# REGIONAL REVIEW FINDING

**Name of Proposal:** Riverwalk Village

**Submitting Local Government:** City of Roswell

**SUBJECT:** **Transportation Division Review of DRI # 2456**

# GRTA Site Plan

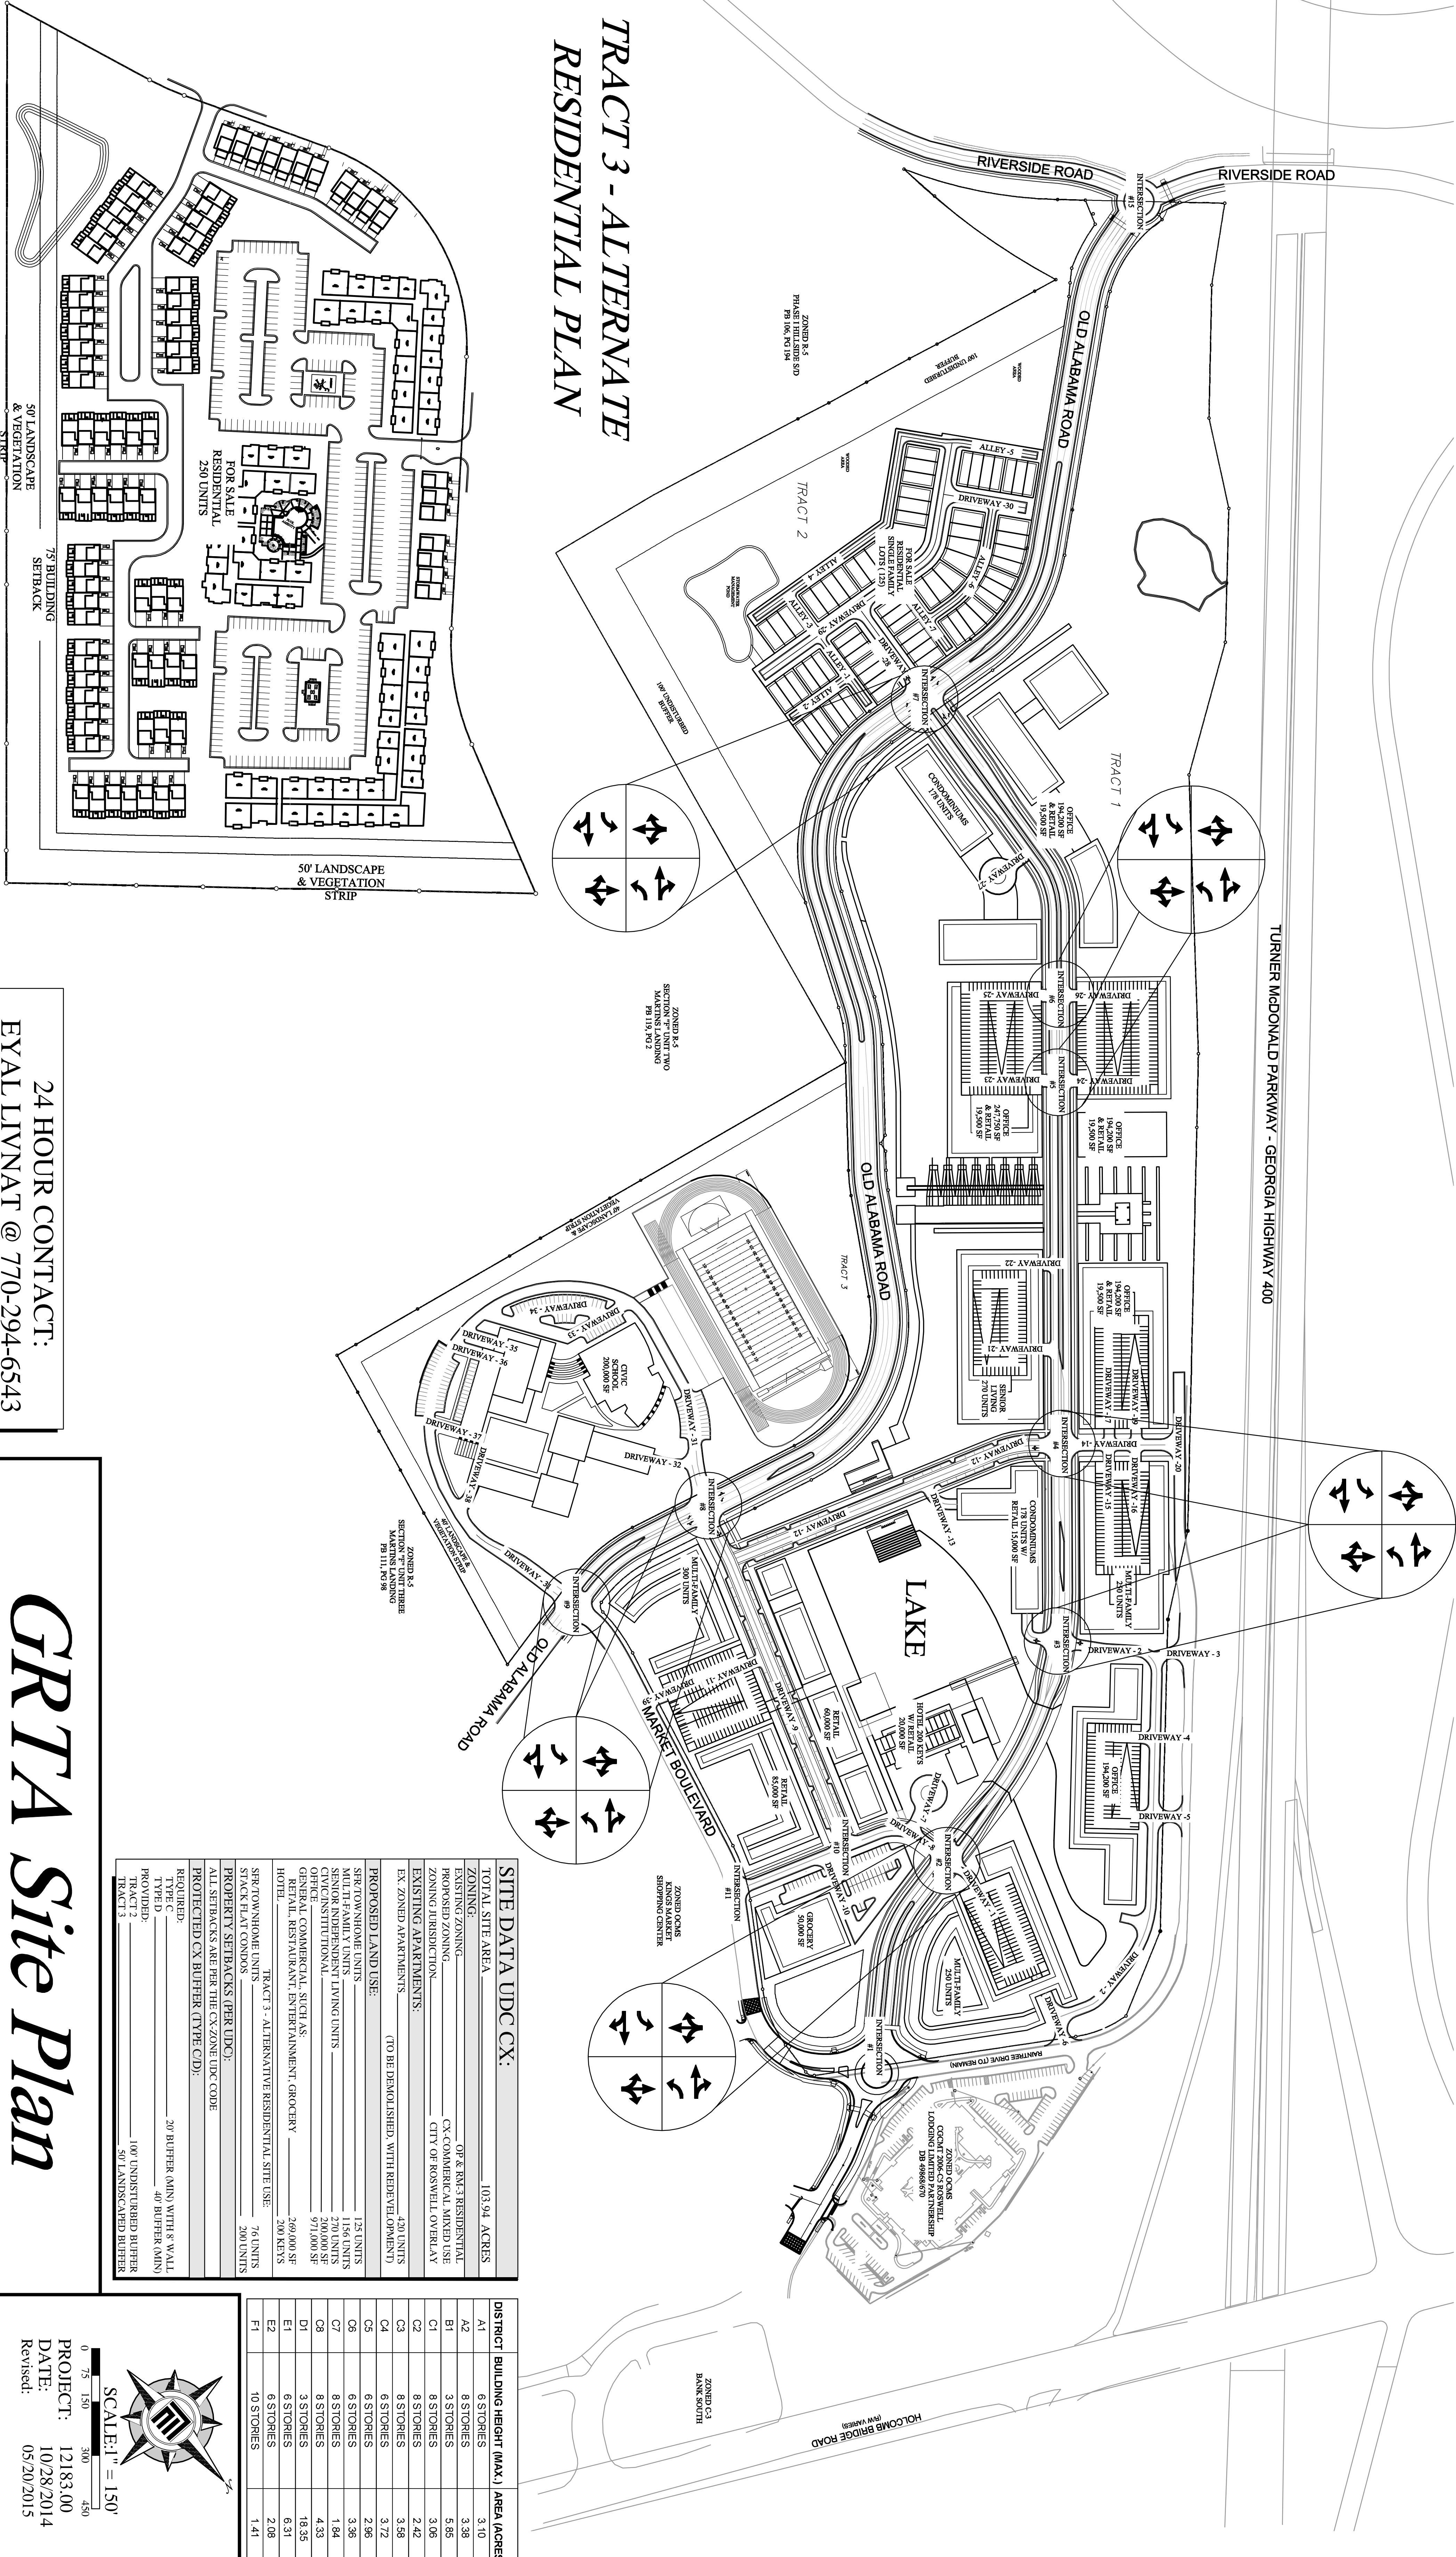
The site plan and supporting materials indicate the developer's desire to create a mixed-use, walkable development. As such, all buildings should "front" public streets and parking should be behind or beside buildings and screened from view. It appears that several parking lots or decks may be proposed for the Market Boulevard and other internal roads located in the northern portion of the site.

Additionally, the developer and the City should investigate potential connections to adjacent properties. These connections can be for all modes or be limited to bicyclists and pedestrians. While these connections do not have to be created by the time the proposed development is completed, potential connections should be preserved so that future access can be created when appropriate.

The site plan includes an alternative use for Tract 3. This alternate includes residential instead of civic uses. The current propose layout of the residential plan for Tract 3 includes two separate driveways that each serve separate pods of development. The developer should consider integrating the two pods and allowing all of Tract 3 to utilize the two driveways.

There is some concern with the spacing between Intersection #8 and the Intersection of Driveway 12 and Driveway 9 (not labeled). The current spacing may not allow for adequate storage of left turning vehicles, once they have entered the site. The developer should consider increasing the distance between these two intersections or limiting turning movements between Driveway 9 and Driveway 12.

The intersection of Driveway 9 at Driveway 12 appears to be within 100 feet or less of Intersection 8. Driveway 12 should be moved further from Intersection 8. If this is not possible due to the location of the existing lake, then the intersection of Driveway 9 at Driveway 12 should allow right-in/right-out movements only. This will reduce the impacts of queueing and other issues from the intersection of Driveway 9 at Driveway 12 on Intersection 8.

If the early off-ramp project is implemented, then Driveways 3, 4, 5, and 6 may not be permitted by GDOT and/or the City of Roswell, due to the need to limit access on this connection from SR 400. Additional coordination with GDOT and the City of Roswell should be conducted to determine the viability of these proposed driveways.

A least one viable location for an external roadway and bike/ped connection should be provided on both the east and the south sides of Tract 2.

The site plan shows parking provided throughout the development. Details about the number of parking spaces provided and their locations should be provided in the traffic report or identified on the site plan.
